3. Tutl'uh Subdivision 2026 Replat; KPB File 2025-116  
McLane Consulting Group / Gwartney  
Location: Hope Hwy, Second Street & Wagon Trail Road  
Hope Area / Hope-Sunrise APC

**ITEM #3 - PRELIMINARY PLAT  
TUTL'UH SUBDIVISION 2026 REPLAT**

<b>KPB File No.</b>	2025-116
<b>Plat Committee Meeting:</b>	April 13, 2026
<b>Applicant / Owner:</b>	Frank Gwartney of Anchorage, Alaska
<b>Surveyor:</b>	Andrew Hamilton; McLane Consulting Inc.
<b>General Location:</b>	Between milepost 16 and 17, Hope Highway, Hope

**T/V/L/U/I SUBDIVISION 2026 REPLAT**  
A SUBDIVISION OF LOTS 4 & 5 OF PLAT 2021-02 & LOT 6A OF PLAT 2022-11 SEWARD RECORDING DISTRICT (SRD)

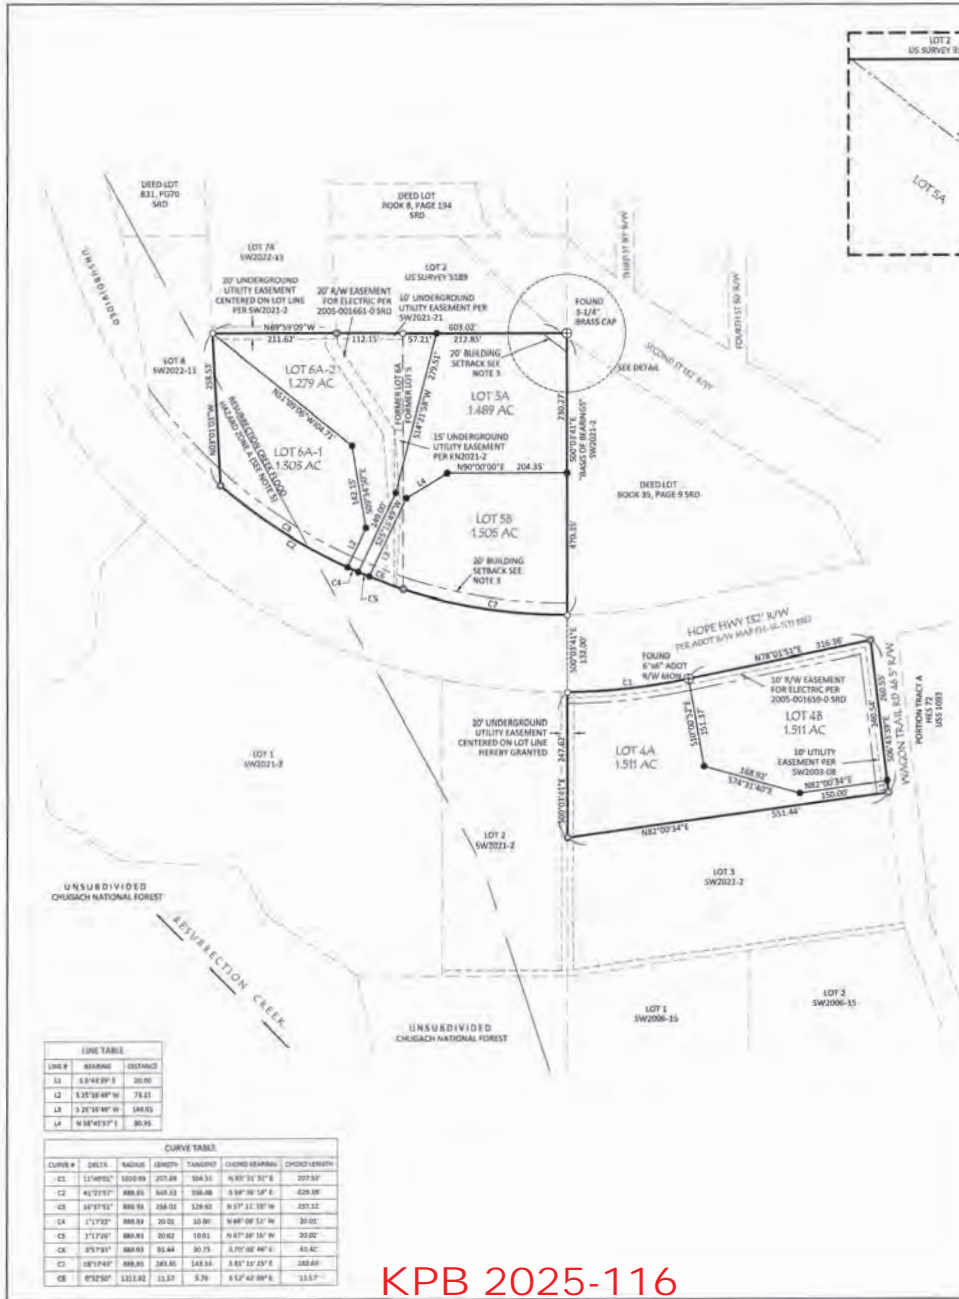
**Staff recommends** adding a note to the final plat referencing DOT&PF access requirements for the proposed lots.

The boundary of Chugach National Forest lies within the adjacent parcels to the south. **Staff recommends** the surveyor depict and label this boundary on the final plat.

KPB reviewers have confirmed that the platting area lies entirely within a non-regulatory Flood Zone, Flood Zone C (FEMA map panel 020012-1125A), an area of minimal flood risk. No depiction of the flood zone is required. **Staff recommends** the flood zone A depiction be removed from the final plat and revise plat note 5 to reference the correct flood zone.

Proposed lots 4A, 5A, and 6A-2 are flag lots, and each access strip meets the requirements of KPB 20.30.190(B). **Staff recommends** including the standard flag lot note on the final plat.

Tutsilitnu Subdivision (SW 2003-8) granted a 10-foot utility easement along all street rights-of-way, increasing to 20 feet within 5 feet of side lot lines. This easement affects proposed lots 4A and 4B. **Staff recommends** the easement

be correctly depicted within 5 feet of the side lot lines on the final plat and that a plat note be provided referencing the utility easement. The easement label should include a reference to the corresponding plat note.

Tut'uh Subdivision (SW 2021-2) granted underground utility easements as depicted on the preliminary plat. **Staff recommends** modifying the label for the 20' underground utility easement located on the western boundary of Lot 4A to reference the parent plat.

Staff has determined that the easements listed in plat notes 8.1 and 8.3 do not affect this plat. **Staff recommends** the applicant confirm these easement locations and, if in agreement, remove the notes and request that the title company remove the associated easements from the final CTP.

The northern portion of the subdivision should include a 10' utility easement adjacent to all rights-of-way, granted by this plat pursuant to KPB 20.30.060 (D).

- o Label the 20' building setback on Lots 4A and 4B.

- o Plat note 8.4: correct the typo by removing "8" in the first word "an."
- o Plat note 8.5: CCR as recorded in document serial number 2021-000225-0 SWD affects only proposed lots 4A and 4B. Include recording district in plat note.

- Staff recommendation:**
- Within the legal description:
    - o Modify legal description to include N1/2 of Section 33
    - o Include names of parent plats

- Remove AKA Frankel Gwartney from the ownership to reflect CTP and KPB records.
- C. The location, width, and name of existing or platted streets and public ways, railroad rights-of-way, and other important features such as section lines or political subdivisions or municipal corporation boundaries abutting the subdivision;

- Staff recommendation:**
- o Depict and label the boundary of Chugach National Forest
- D. A vicinity map, drawn to scale showing location of proposed subdivision, north arrow if different from plat orientation, township and range, section lines, roads, political boundaries, and prominent natural and manmade features, such as shorelines or streams;

- Staff recommendation:**
- o Provide a label for R02W.
  - o Depict and label Porcupine Creek within section 29.
  - o Depict and label Bear Creek within sections 29, 33 and 34.

- o Depict and label Cripple Creek within Sections 32 and 33.
  - o Provide a label for wagon Trail Road.
  - o Distinguish the boundary of Chugach National Forest more clearly as it affects the entire vicinity map excluding only a portion within sections 28 and 33.

- Staff recommendation:**
- o Modify the utility easement label located on the western boundary of Lot 4A to "per SW 2021-2"

- Staff has determined that the easement described within recorded document Book 114 Page 740 SWD does not affect this plat. Please confirm and if in agreement, remove plat note 8.1.
- Staff has determined that the easements listed in document 2005-00166-0 SWD does not affect this plat. Please confirm and if in agreement, remove plat note 8.3 and request title company to remove from the final CTP.
- Per SW 2003-8: depict the easement within 5' of side lot lines and provide a plat note referencing the utility easement extending to 20' within 5' of side lot lines for proposed lots 4A and 4B. Include reference of the corresponding plat note within the utility easement label.

- Please include surveys and associated lots on applicable parcels abutting plat. Deed references may be kept:
  - Revise book number: Book 35D Page 9 SWD; Include: PTN of Tract B, USS 1093
  - Book 8, Page 194 SWD; USS 1485 South 90' Block 11
  - Book 31, Page 70 SWD; PTN Lot 1, USS 3189

**Staff recommendation:** Northern portion of subdivision should include 10' utility easement GTP.

**Staff recommendation:** place the standard note on the plat for the flag lot(s): No structures or wastewater disposal area are permitted within the panhandle portion of the flag lots 4A, 5A, and 6A-2.

- o Remove Frankel Gwartney from ownership line and notary's acknowledgement.
- o Revise the Plat Approval to KPB 20.60.190 (C)

**Staff recommendation:** modify plat approval to reflect code.
